**KNOXVILLE/KNOX COUNTY METROPOLITAN PLANNING COMMISSION
SUBDIVISION REPORT - CONCEPT**

▶ **FILE #:** 10-SA-07-C

▶ **SUBDIVISION:** SHANNON VALLEY FARMS, UNITS 4C & 5

10-SA-07-C
CONCEPT PLAN

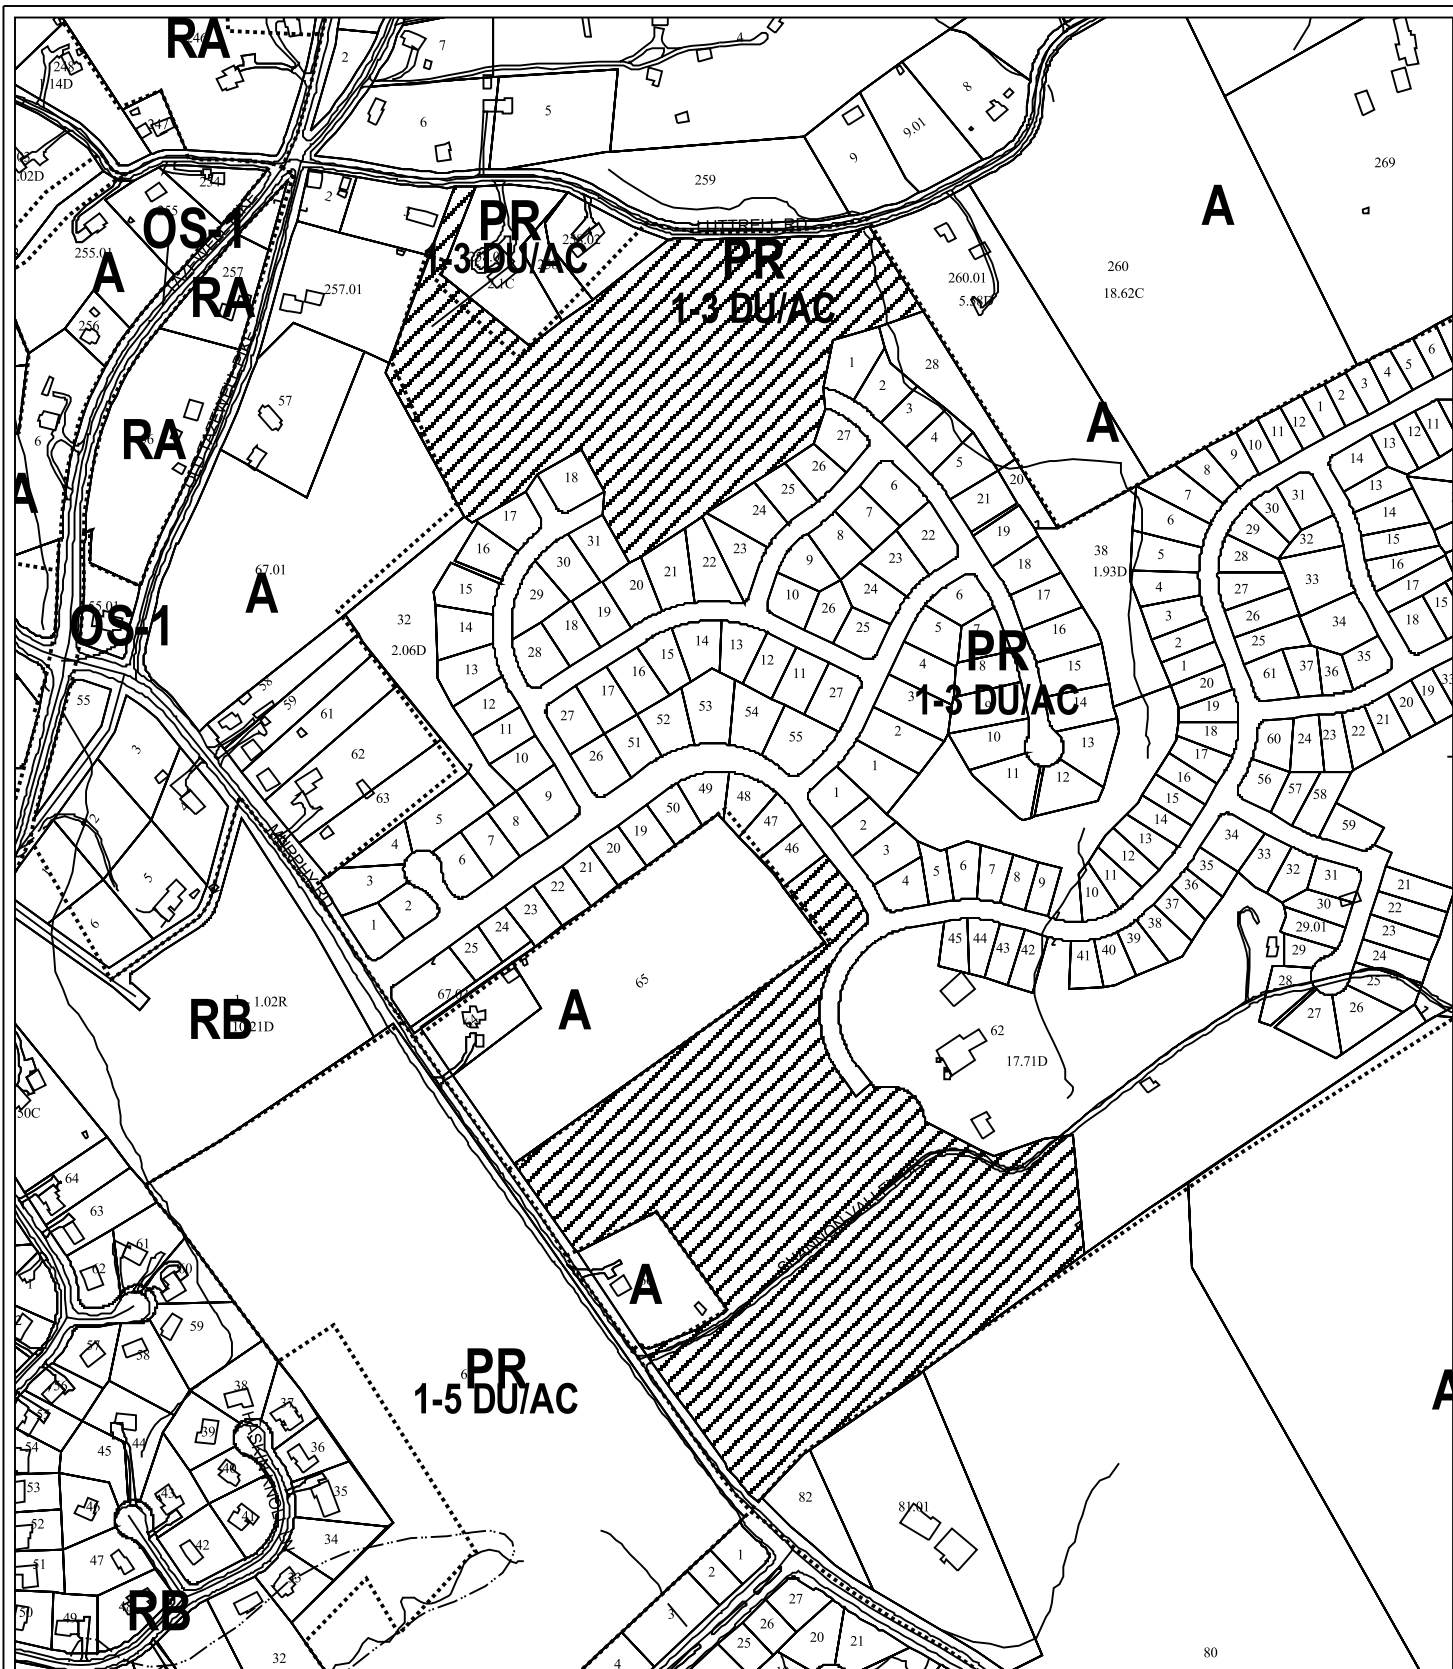
▶ **SUBDIVISION VARIANCES REQUIRED:**
1. Horizontal curve variance on Road A (Unit 5) at STA 9+50, from 250' to 225'.
2. Vertical curve variance on Road A (Unit 5) at STA 6+50, from 75' to 50'.
3. Reduction of the right-of-way corner radius at the northeast corner of the intersection of Road C and Murphy Rd. (Unit 5), from 25' to 0'.

▶ **APPROVE** variances 1-3 because the site's topography and site features restrict compliance with the Subdivision Regulations, and the proposed variances will not create a traffic hazard.

4. Revising the concept plan for Unit 5 to include the strip of property between the Road C right-of-way and the existing lot to the north (tax parcel # 049 066) into the right-of-way for Road C.
